# CI 136.8.11 Link Training Issue (comment #1)

Oct 2020

Kent Lusted, Intel

Figure 136-7—PMD control state diagram

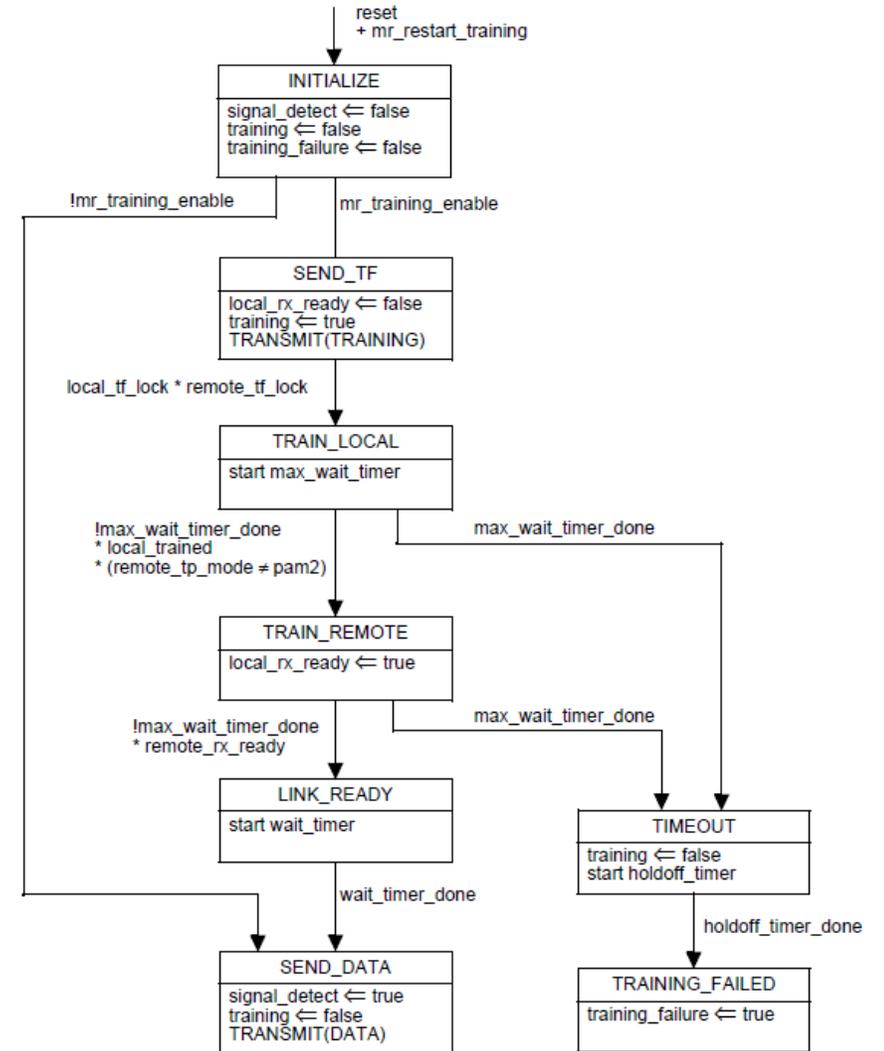
- The currently defined state machine in Clause 136.8.11 (Figure 136-7) does not autonomously recover from a partner restarting during link training in this “force PHY speed” case
  - Note: observed when the Clause 73 Auto-Negotiation state machine is not used.
- Unless a high-level management agent (i.e. SW or FW) detects the condition, the result could be either a persistent link down (i.e. link never comes up) or a link oscillation (up/down/up/down/etc).

- Reset of Device #1 was not captured by Device #2
- The signals local\_tf\_lock and remote\_tf\_lock are only checked moving from the SEND\_TF state to the TRAIN\_LOCAL state.
  - Note: CI 73 AN state machine (if it was used in this case) would expire link\_fail\_inhibit\_timer and breakout out of the condition

- Add monitoring of the local and received frame lock status (with TBD hysteresis) after the initial frame lock is achieved
- Implement an abort signaling mechanism
